RE: 229 Edmund Place Carriage House Revisions November 2022

This document and the accompanying attachments seek HDC's support and approval for (1) increasing the previously approved 4 space side parking area to 6 spaces along with updated landscaping plans and (2) minor floor plan and resulting elevation changes to the Carriage House design due to DTE Energy power line setbacks not identified during the P&DD review and BSEED permitting process.

Section 1 – Firepit area vs. Fire Table

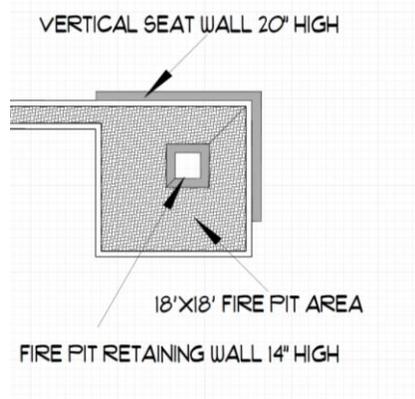
A sitting area will be constructed using the Fendt Holland Burgundy blend pavers. A vertical seat wall and 14" high fire pit will be constructed with the same pavers and capped with limestone pieces.

Sidewalk and East and West property lines up to front face of the house

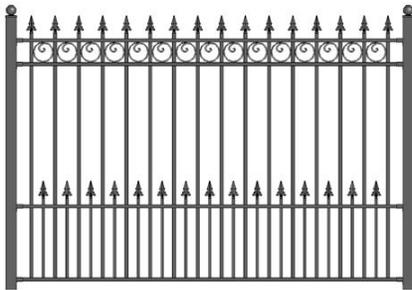
- 4' H x 8' L sections of black, aluminum or metal fencing in like the photo below. Front gate at sidewalk will be of similar pattern and style.

East and West Property Lines from front face of house to Rear property Line

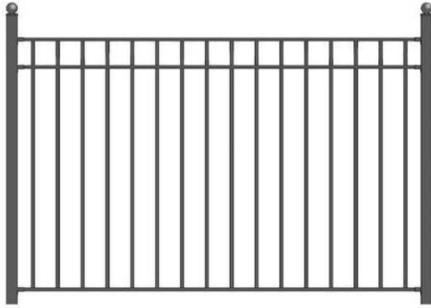
- 6' H x 10' L sections of aluminum fencing with powder-coat of black paint like the photo below.
